Re: Request to Approve
Culvert Extensions
Savage Services Corporation
Savage Coal Terminal
C/007/0022

Permittee: Savage Services Corporation
Mine: Savage Coal Terminal **Permit Number:** C/007/0022
Title: Proposed Culvert Extensions

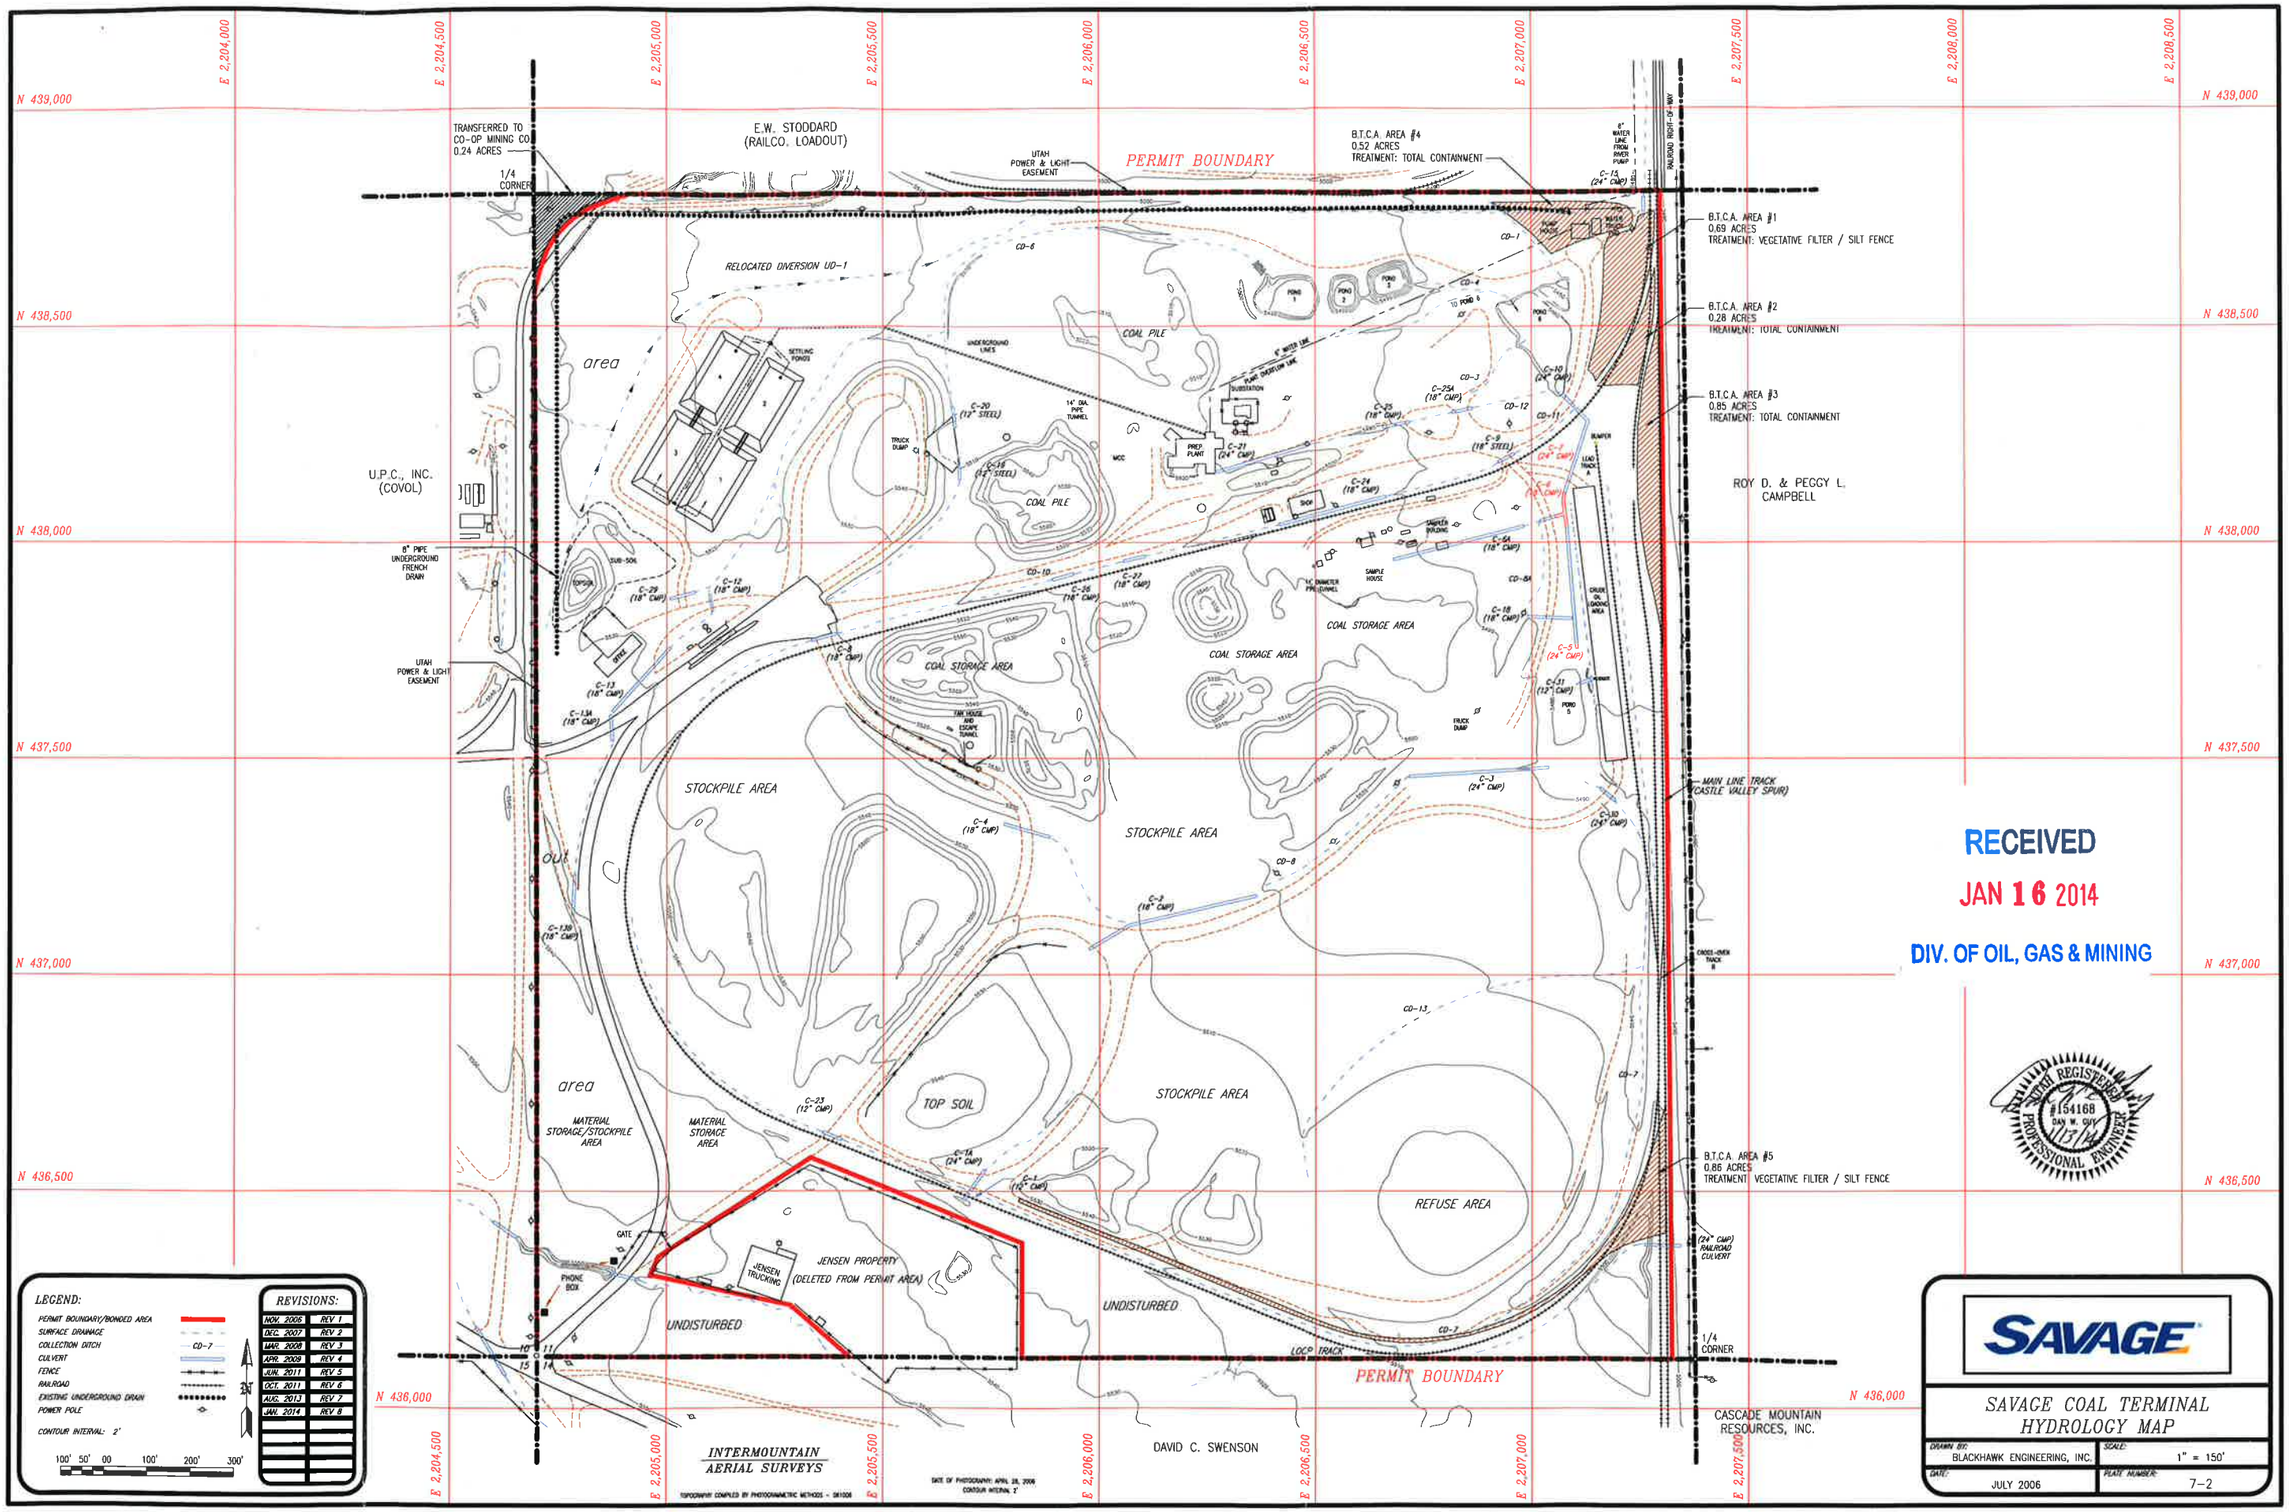
This amendment is to extend existing 24" culvert C-5 to connect to the existing 24" culvert C-7, and to extend existing 18" culvert C-6 to connect to the extended section of C-5. This connection will allow the closure of the open hole between the culverts and enhance the safety of the trucks and equipment traveling through this area. This closure will not alter any drainage in the area, since there are no surface ditches draining to the open hole, and the culverts will still carry the same runoff to the outlet of C-5 into Sediment Pond 6. The culvert names will remain the same, since the separate sections will each carry the same drainage as they do now; therefore, only the culvert lengths have been changed on Table 7-25. Culvert connections are shown on enclosed Plate 7-2.
